REQUEST FOR BIDDING INTERPRETATION (RFBI)

PMDB RFBI No.: Requestor RFBI No.: 01 **Request Date:** 12/19/2025 From (Bidder): McCarthy

000000000009324 Project No.: Project Name: **OES Security Upgrades**

Drawing Reference: E101 , E421 Project Manual Reference:

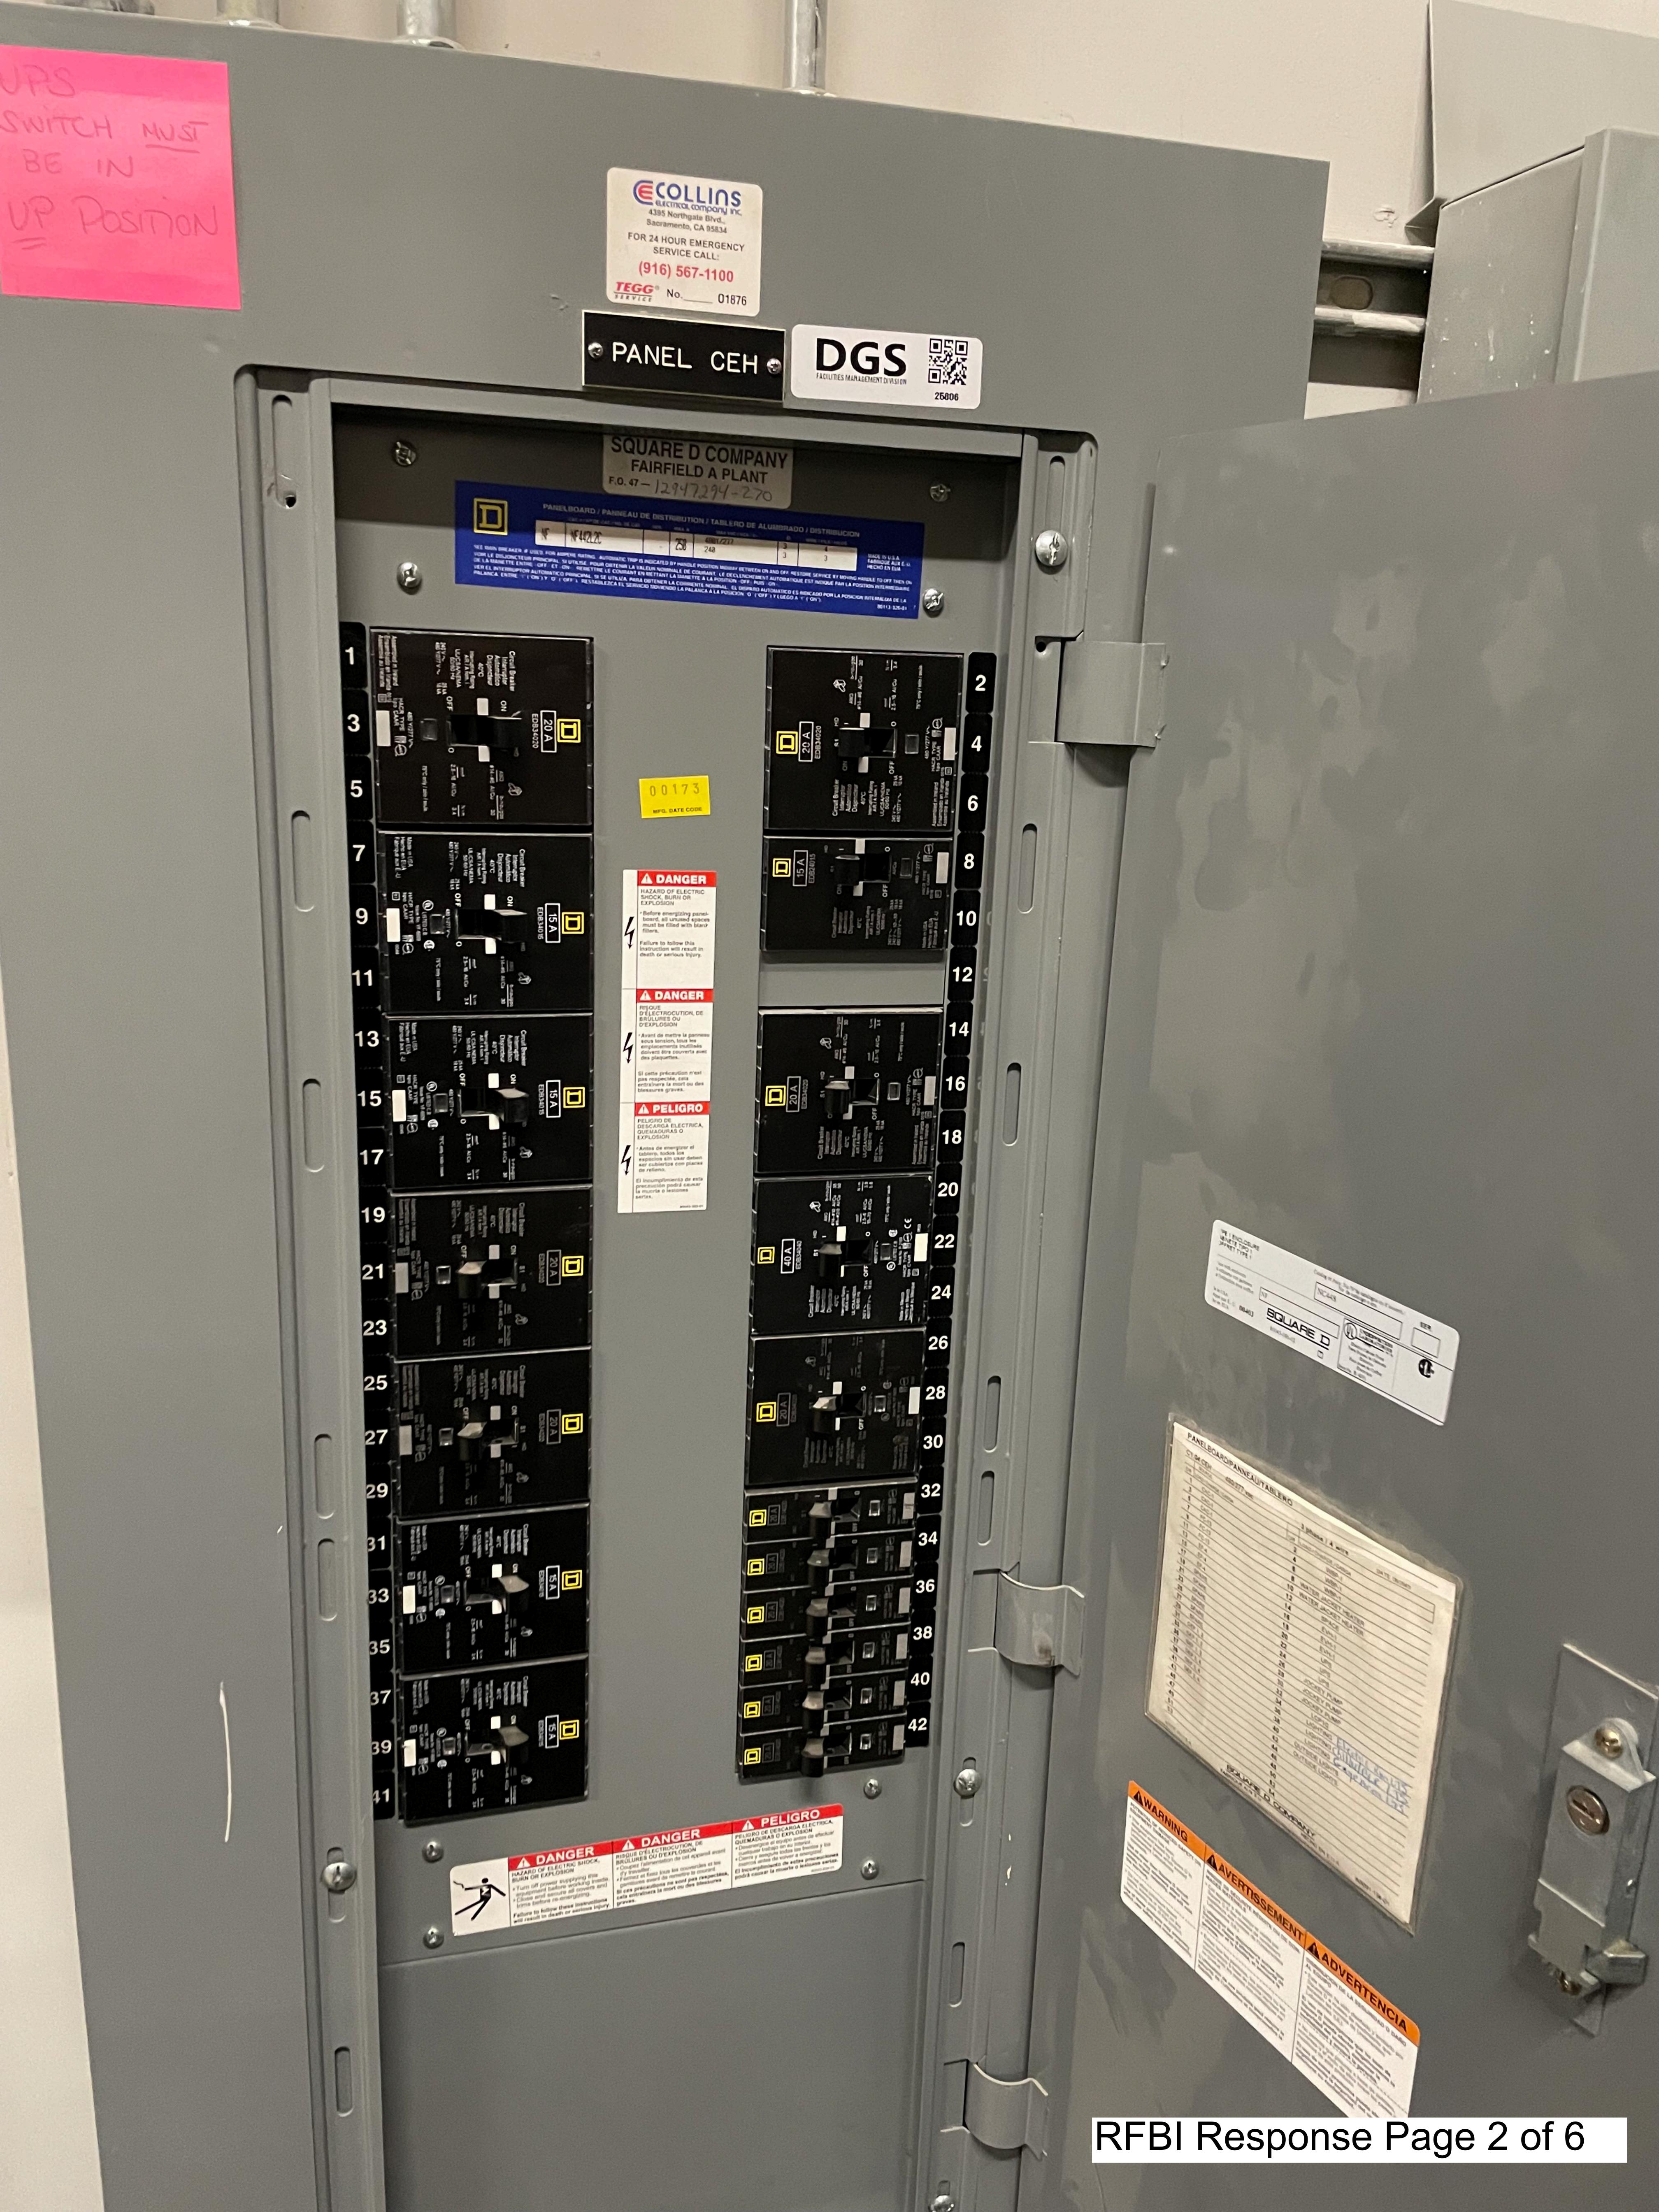
Drawing E101 Keynote 2 calls for a new 40A, 3-pole circuit breaker to be installed in existing panel CEH.

Drawing E421 Keynote 1 calls for a new 40A, 3-pole circuit breaker to be installed in existing panel BEDP.

Please confirm and specify the manufacturer and catalog/part numbers for each of these required circuit breakers that are compatible with the existing panelboards CEH and BEDP, including any required accessories or kits (e.g., filler plates, mounting hardware, or retrofit components).

Contractor shall refer to Construction Documents for power and circuiting requirements for each breaker. See attached pictures for existing panel rating and existing circuit breaker photos as reference to help determining compatibility.
